Access Compliance Report Public Rights-of-Way (Curb Ramps)

Main Street: WINTHROPE_ST Cross Street: DODGE_AVE Location: NE

ADA ID: RPAT211019125827 Ramp Type: Type 1 - Perpendicular Diagonal Initial Pass/Fail: Pass Overall Compliance: No Severity Score: 0

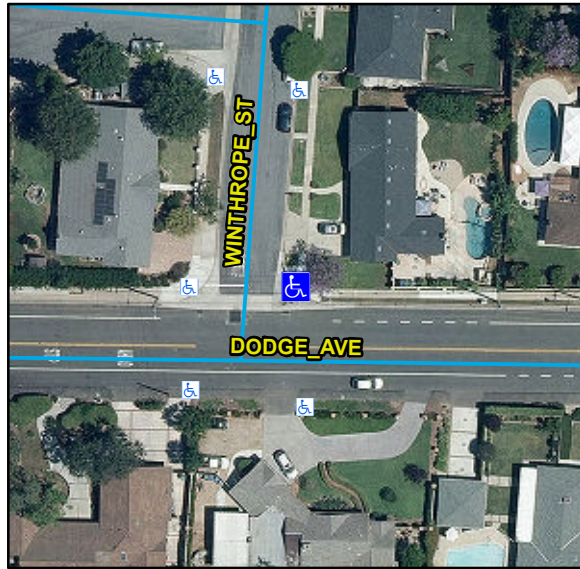
R304.2.1, STD 1115

Remove & Replace Landing.
